STAFF REPORT AND RECOMMENDATION TO THE DESIGN COMMISSION

CASE FILE: LU 14-117884 DZM
 PC # 14-115494
Block 37 – South Waterfront

WHEN: August 21, 2014 at 1:30 PM

2 WEST ELEVATION

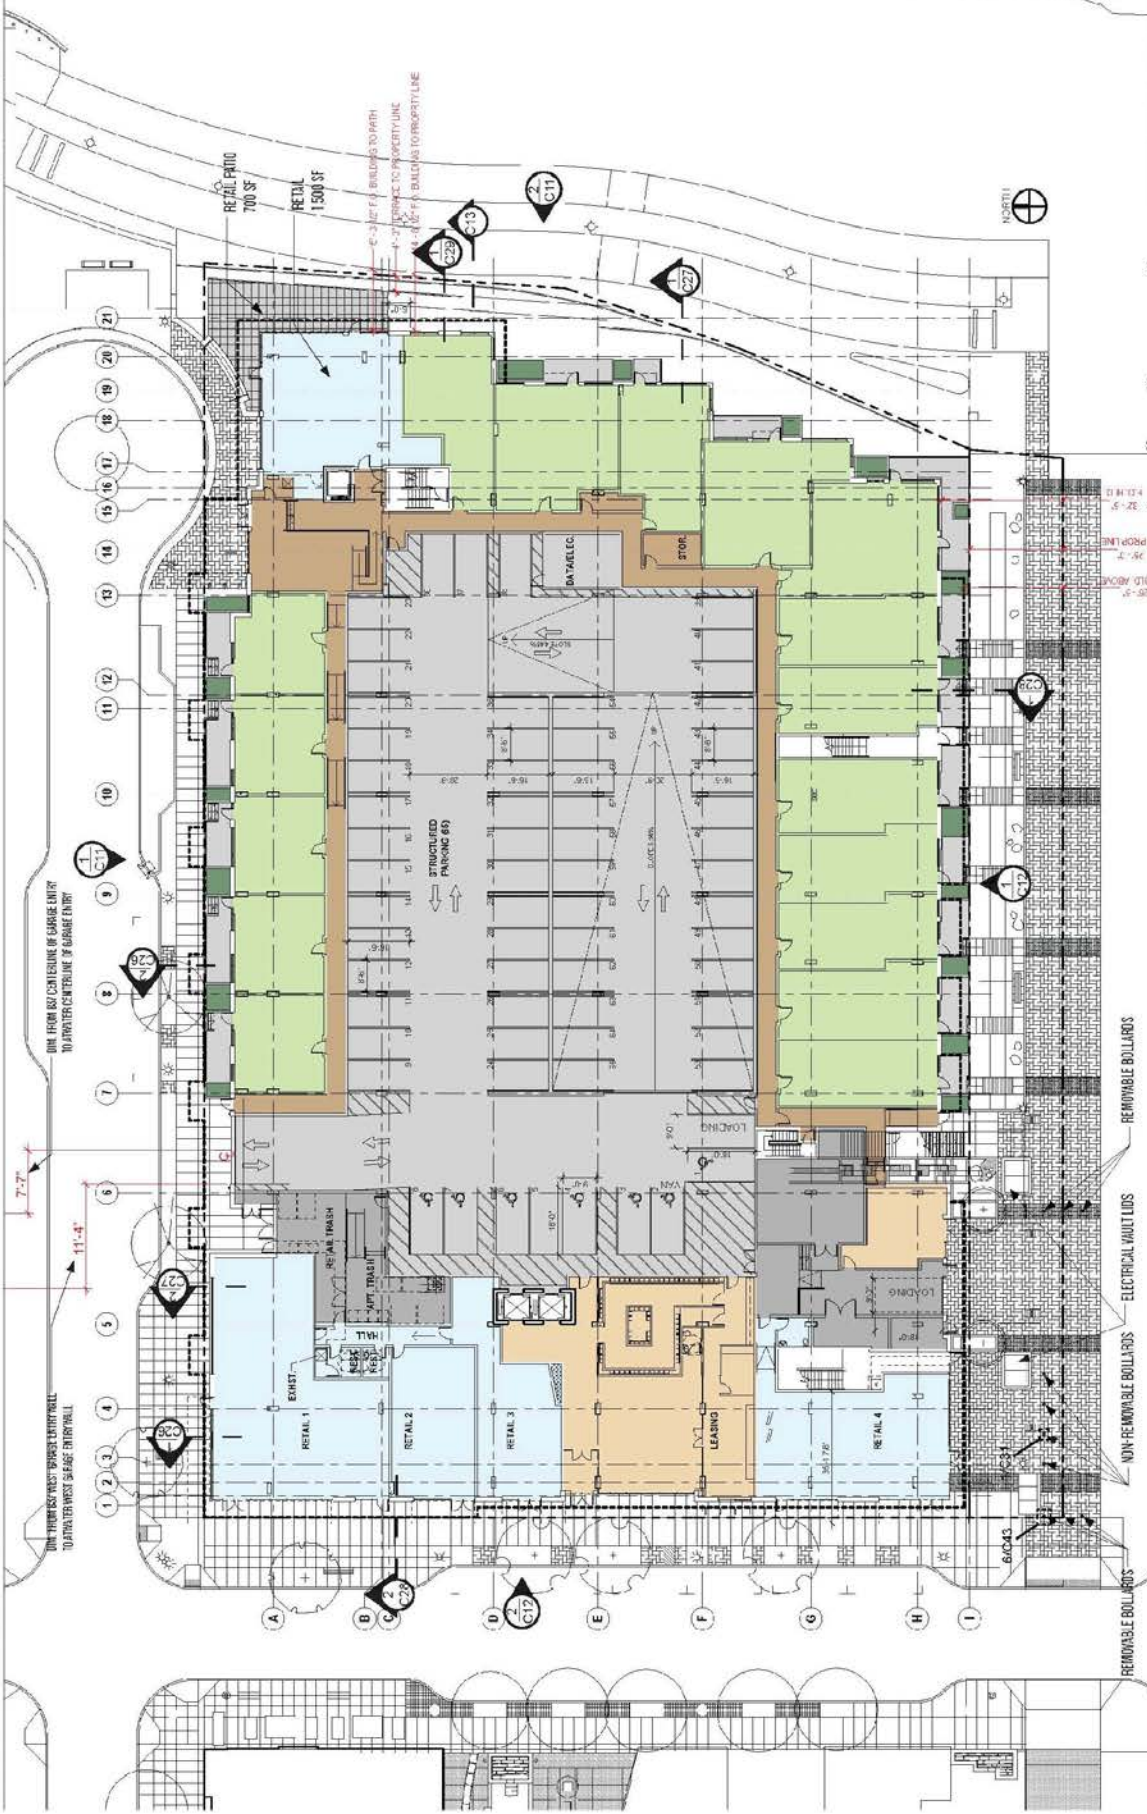
- B. A column of 5’ deep inset balconies that extends from the 2nd to the 6th floor shall be added to the west facade that matches the proportions and design of the balconies on the north and south facades.
- C. The lid covers to the underground vault in SW Lane must match the surrounding paving treatment, as specified in the South Waterfront street plan or, at minimum, be painted to match the colors of the surrounding pavers.
- D. The applicant shall work with Staff on an alternate design solution for the non-removable bollards proposed to protect the underground vaults in the Lane accessway from vehicle traffic. If the solution requires a Type 2 Design Review, the Design Review approval must be final prior to issuance of main building permit.
